AS-BUILT PLANS

PRIVATE WATER DISTRIBUTION SYSTEM IMPROVEMENTS

WICHITA BIOMEDICAL CAMPUS

PROJECT NO. 2024-006370PPW
ORG CODE 54030980

WATER LINES

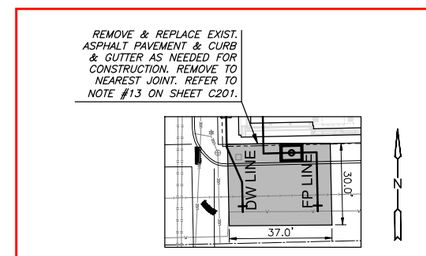
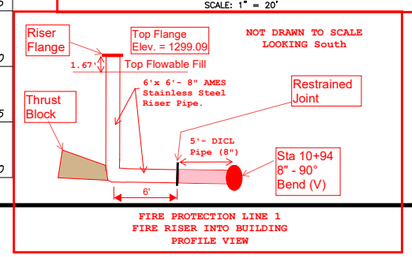
See As-Built Sketch Below

NOTES:
1) No Test Stations installed. Tracer Wire installed in TAP Valve Boxes.
2) Baughman Inspection ended on Domestic Line at Sta 10+98 (Temporary 2" Blow-Off Valve).

NOTES:
3) Domestic Water Line installed on Plan Alignment.
4) Domestic Water Line from Sta 10+98 to Riser installed by Others.

WATER LINES

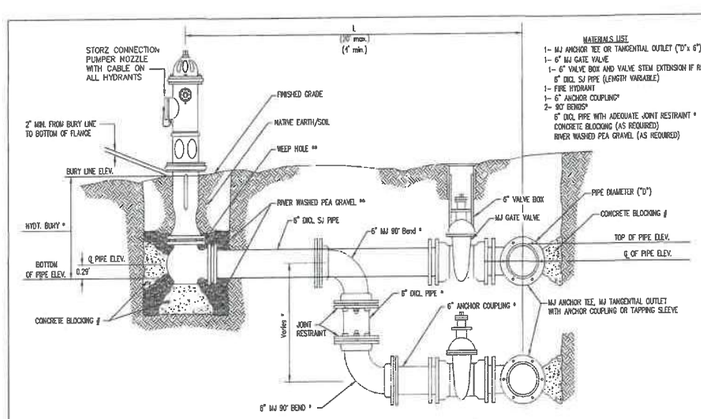
SEE REVISED SHEET - REVISION 8-14-24 - ON PREVIOUS PAGE

FIRE HYDRANT ASSEMBLY

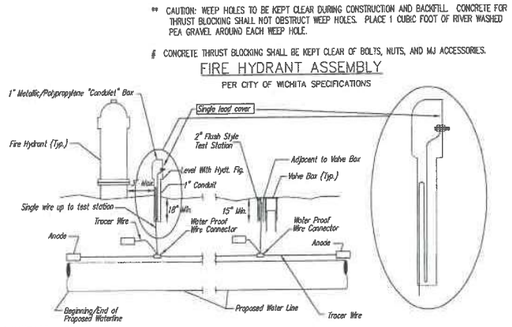
Revision to original approved plans to add these two fire hydrants

FIRE HYDRANT RELOCATIONS

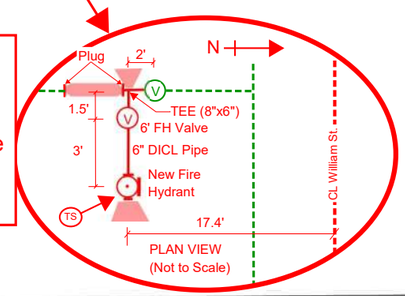
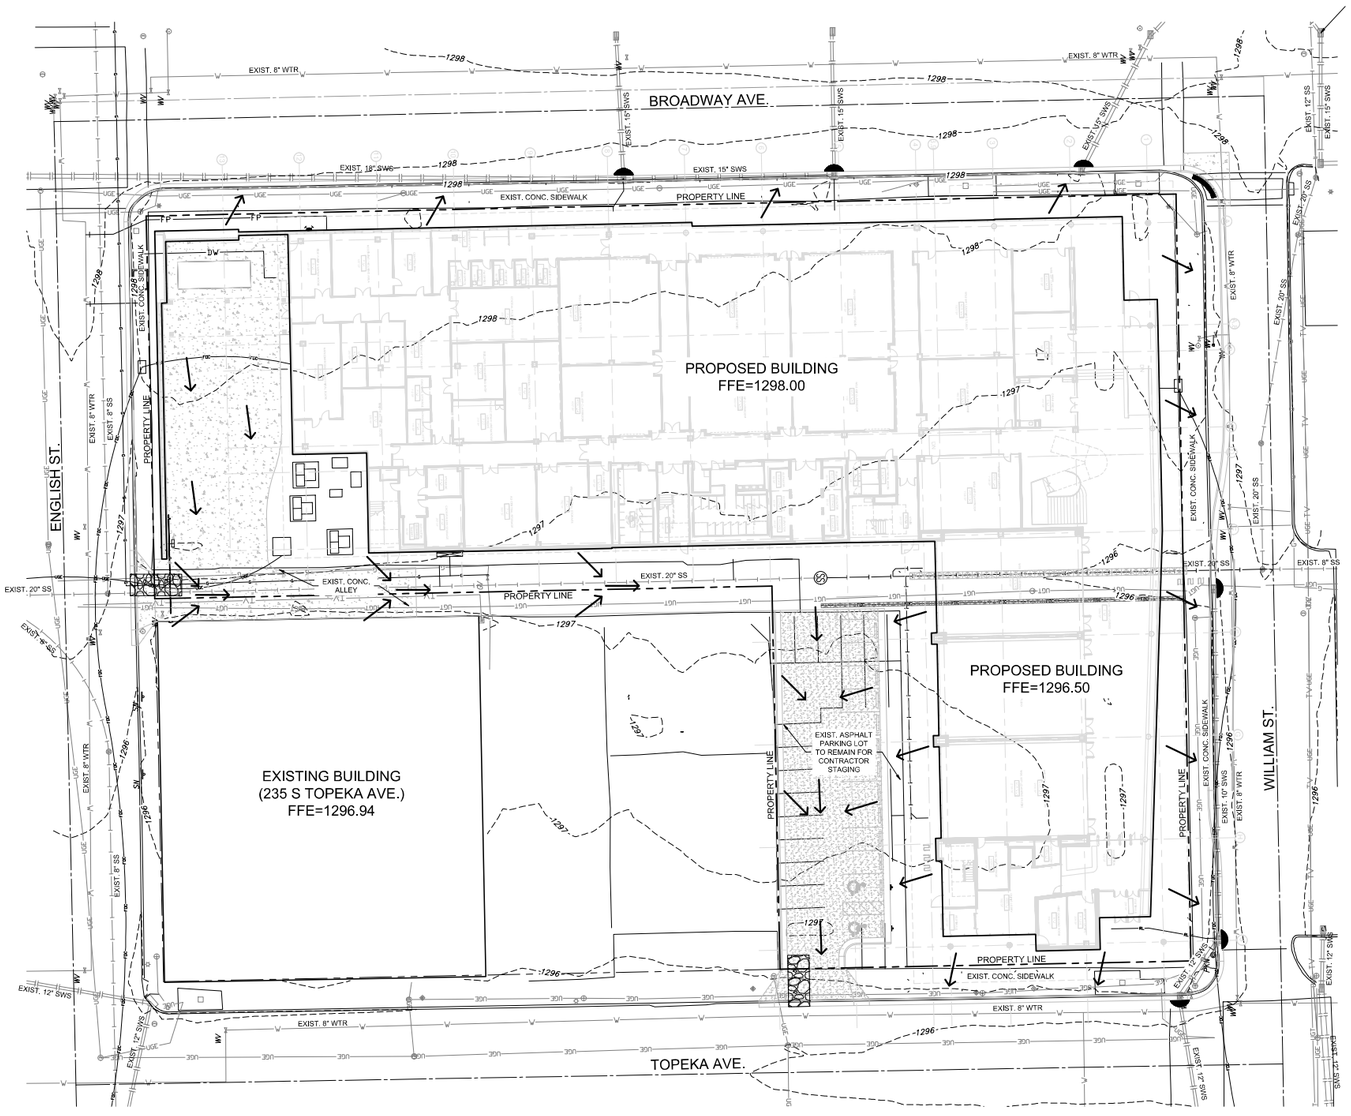
Revision to original approved plans to add these two fire hydrants

REMOVE 6 L.F OF 8" WATER LINE.
1-FIRE HYDRANT ASSEMBLY
L=4.0'
Facing North
BURY LINE ELEVATION=~~1297.57~~ 1297.90
1-8" PLUG (S)
~~N=1685409.48, E=1649575.72~~

CONTRACTOR TO INSTALL RESTRAINED VERTICAL BENDS AS NECESSARY TO ENSURE CLEARANCE BELOW EXISTING STORM LINE AS-BUILT VERTICAL BENDS AS NECESSARY

REMOVE EXISTING HYDRANT #00628 & SALVAGE BACK TO CITY OF WICHITA.
REMOVE 6" VALVE
PLUG EXIST. ~~HYDRANT TEE.~~ BEND (VERTICAL)
